PROPOSED ALTERATIONS 40 MONASH PARADE, DEE WHY FOR CARYN CAVANAGH		LOT 53A DP101690
--	--	------------------

SITE PLAN & CALCULATIONS		DRG. NO. 08-16-MON
DATE AUGUST 2016	DRAWN J. WRIGHT	SCALE 1:200
		SHEET NO. 5B

PROPOSED ALTERATIONS 40 MONASH PARADE, DEE WHY FOR CARYN CAVANAGH LOT 53A DP101690			
WEST, EAST & NORTH ELEVATION			DRG. NO. 08-16-MON
DATE AUGUST 2016	DRAWN J. WRIGHT	SCALE 1:100	SHEET NO. 3B

SOUTH ELEVATION & SECTION

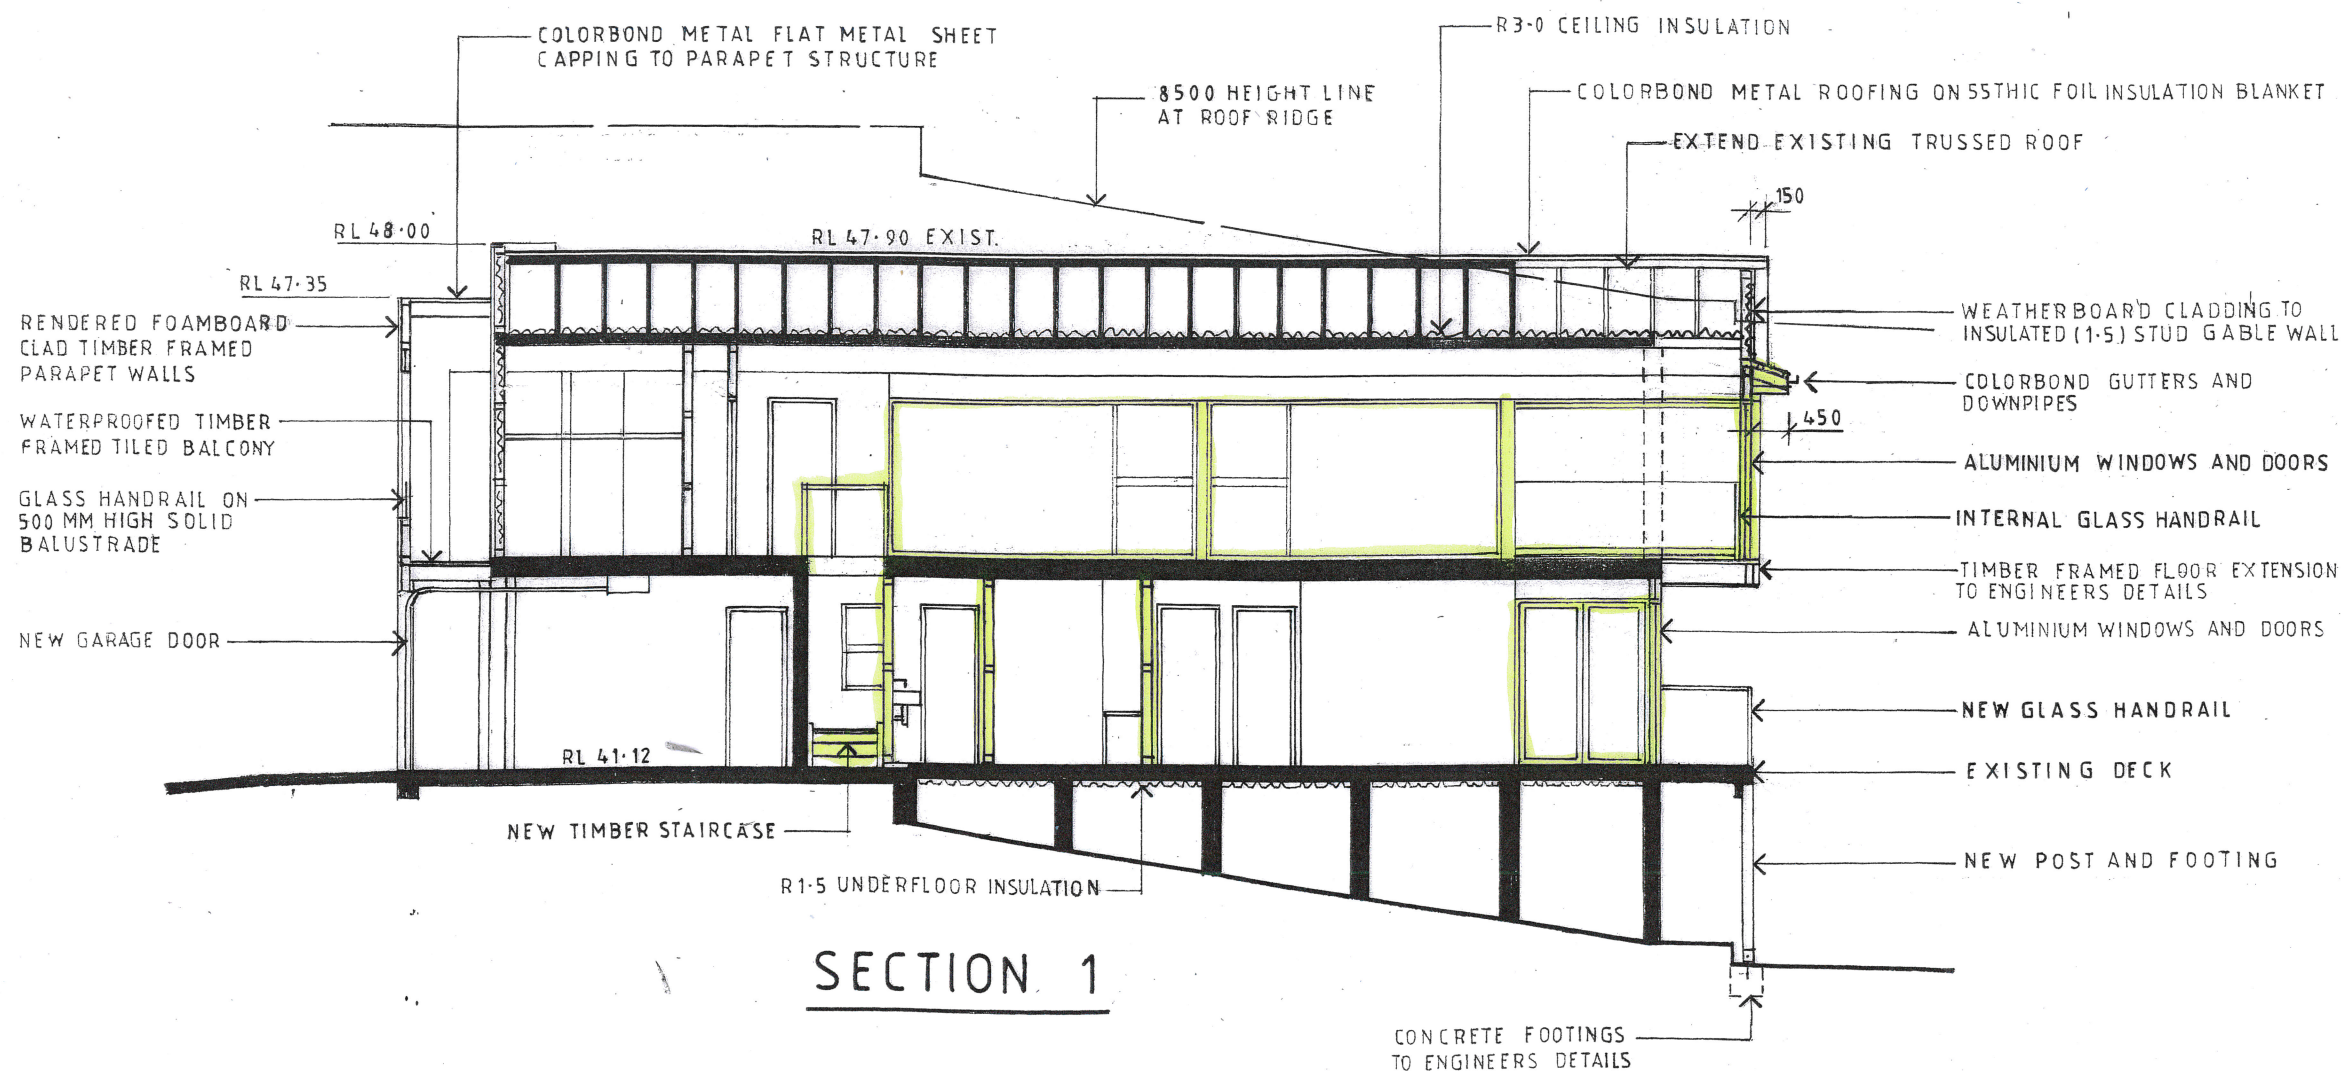
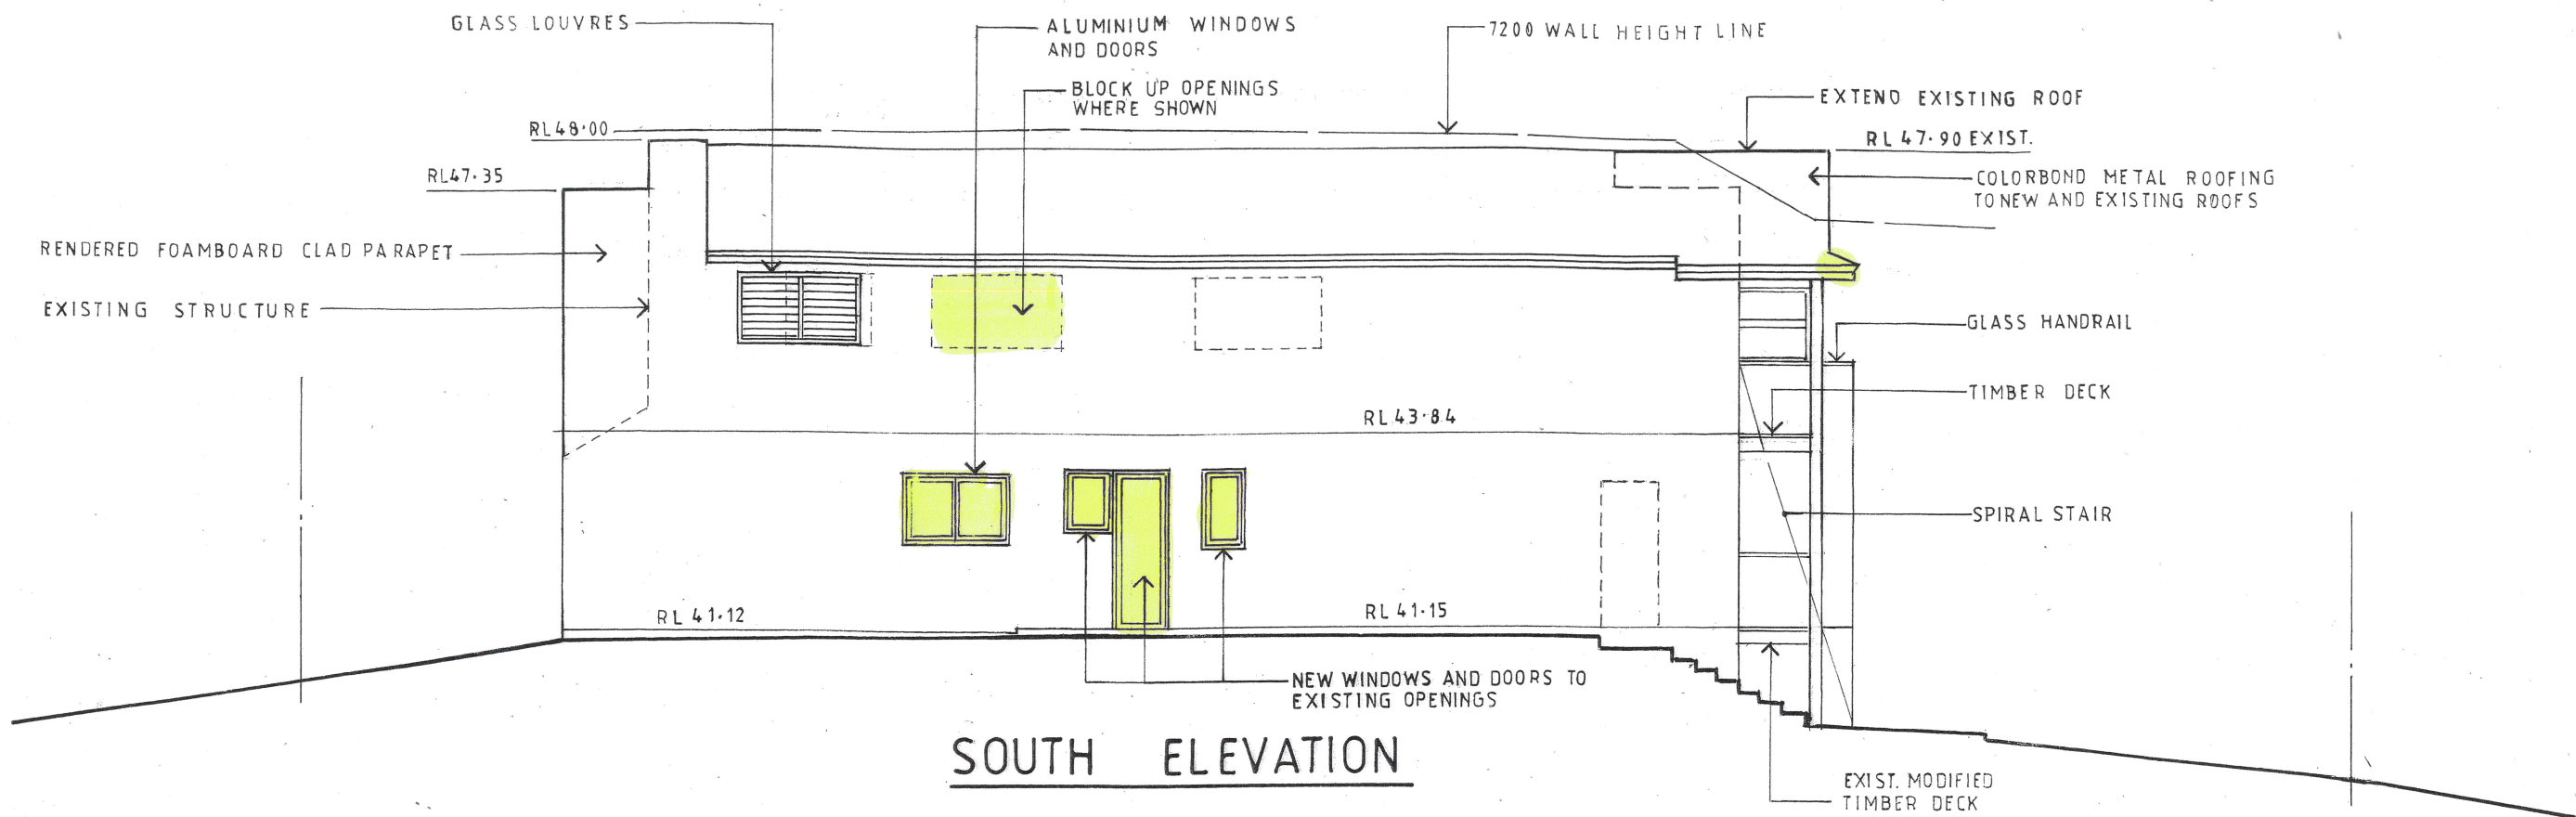
DATE	REVISION
A 12-11-18	FIRST FLOOR NORTHERN WINDOWS REVISED
B 25-11-19	REVISED TO SUIT CHANGES NOTED ON SHEET 1 EASTERN EAVE WIDTH REDUCED
